# Access Compliance Report

## Public Rights-of-Way (Curb Ramps)

Intersection ID: 48960	Main Street: FRANKLIN_SQUARE_RD	Cross Street: BONROI_AV	Location: W
ADA ID: 35FA3D64EFAB	Ramp Type: BlendTrans1	Initial Pass/Fail: Fail	Overall Compliance: No
		Severity Score: 10

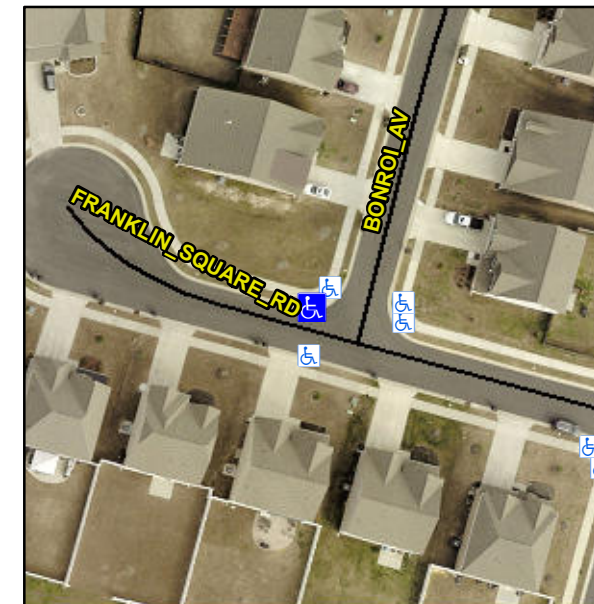
**Not Found, R304.5.1, R304.5.3**

Compliance	Description	Data	Compliance	Description	Data
N/A	Ramp Length (in)	54.5	Yes	BlendTrans Slope (%)	3.5
No	Ramp Width (in)	47.5	No	BlendTrans XSlope (%)	4.9
N/A	Flare Type LT	N/A	N/A	Flare Type RT	N/A
N/A	Flare Slope LT (%)	N/A	N/A	Flare Slope RT (%)	N/A
N/A	Flare Traversable LT?	N/A	N/A	Flare Traversable RT?	N/A
N/A	Landing Length (in)	N/A	N/A	DWS Provided?	N/A
N/A	Landing Width (in)	N/A	N/A	DWS Contrast?	N/A
N/A	Landing Slope (%)	N/A	N/A	DWS Length (in)	N/A
N/A	Landing X Slope (%)	N/A	N/A	DWS Full Width?	N/A
N/A	Landing Curb? (Y/N)	N/A	N/A	DWS Offset (in)	N/A
N/A	Shared Landing?	N/A			
N/A	Gutter Ponding?	N/A	N/A	Gutter Slope (%)	N/A
N/A	Gutter Lip Ht (in)	1.0	N/A	Gutter X Slope (%)	N/A
N/A	Painted X Walk1?	No	N/A	Painted X Walk2?	N/A
	X Walk 1 Direction	To S		X Walk 2 Direction	N/A
	X Walk 1 Width (in)	N/A		X Walk 2 Width (in)	N/A
	X Walk 1 Slope (%)	3.7		X Walk 2 Slope (%)	N/A
	X Walk 1 X Slope (%)	2.1		X Walk 2 X Slope (%)	N/A

N/A	Ramp inside XWalk1?	N/A	N/A	Ramp inside XWalk2?	N/A
	Road Slope (%)	2.1		Clear Space?	N/A
	Road X Slope (%)	3.7	N/A	Clear Space to XWalk (in)	N/A
N/A	Any Obstructions?	N/A	N/A	Storm Grate/Utility Hazard?	N/A
	Obstruction Type			Storm Grate/Utility Type	
		N/A			N/A
			Yes	Surface Condition? (G/P)	Good
			No	Curb Slope (%)	19.4

**Remove & Replace Curb Ramp With Two New Directional Ramps or Equivalent.**
